U.S. Department
of Transportation
**Pipeline and Hazardous
Materials Safety
Administration**

Re: PHMSA Docket No. 2011-0075

DRAFT DECISION

Det Norske Veritas (USA), Inc. (Petitioner or DNV) has filed a petition for approval (Petition) of the PHAST-UDM (Process Hazard Analysis Software Tool – Unified Dispersion Model) under 49 C.F.R. §§ 190.9 and 193.2059(a).¹ This Draft Decision proposes to approve that petition and will be made available for public comment for 30 days. Any comments received during that time will be considered before a Final Decision is issued. Late comments will be considered to the extent practicable.

Figure 1 Predicted Concentration against Measured Concentration

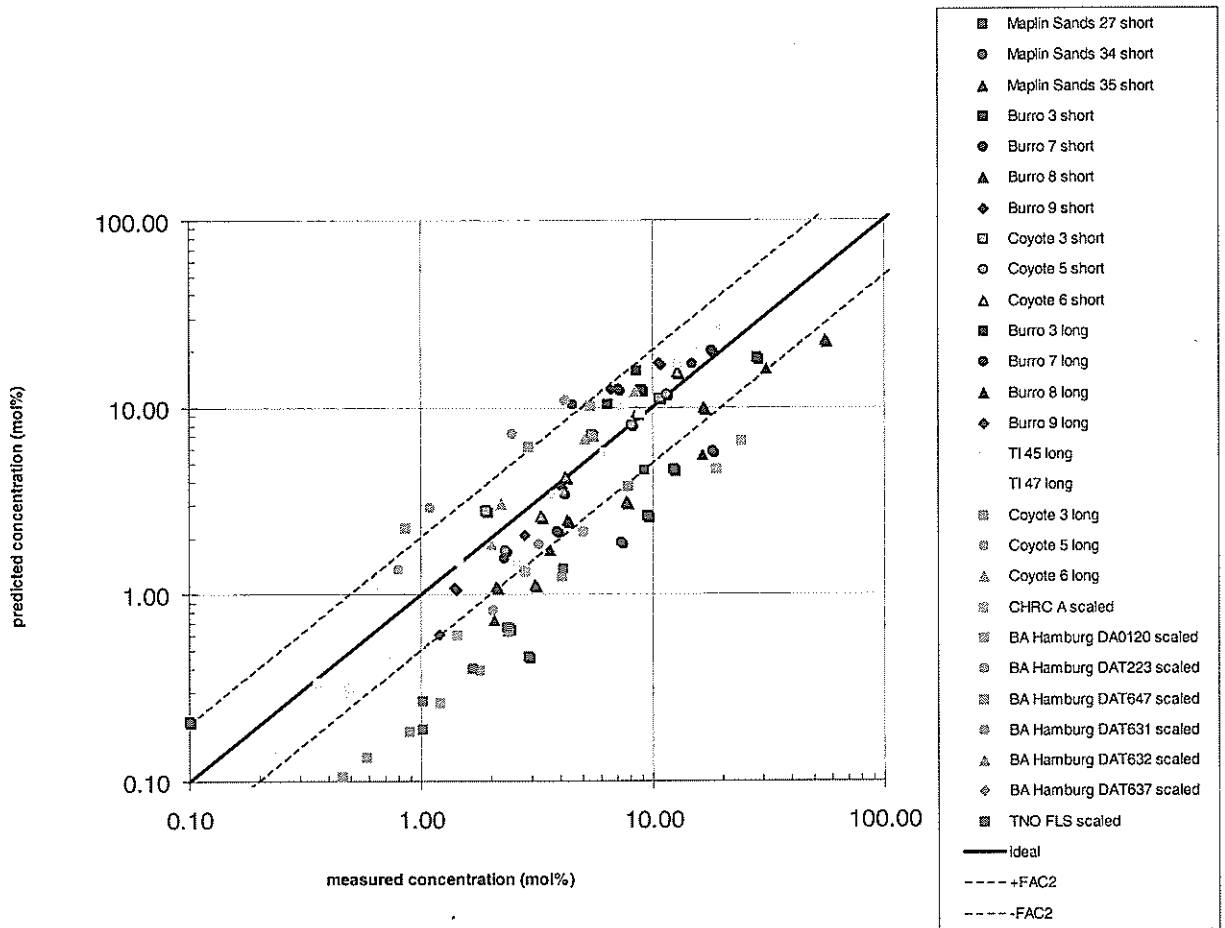
UDM maximum point-wise predictions are generally over-predictive for both short and long time averages, with higher over-prediction for longer time averages. A majority of UDM maximum point-wise concentration predictions were within a factor of 2, but showed a moderate degree of scatter among the predictions. UDM cloud width predictions for both long and short time averages agree very well with experimental cloud width calculations with very little scatter. All UDM cloud width predictions were within a factor of 2.

UDM generally under-predicts point-wise gas concentrations with short time averages and over-predicts point-wise gas concentrations with long time averages with the exception of Burro 8 and Burro 9. UDM is generally more accurate and conservative for point-wise concentrations that are located at an angle corresponding to the wind direction where the maximum arc-wise concentration often occurred, and is less accurate and under-predicts by a greater margin for point-wise gas concentrations that are located farther from the "centerline". However, no clear or similar trends can be found in the wind tunnel tests.
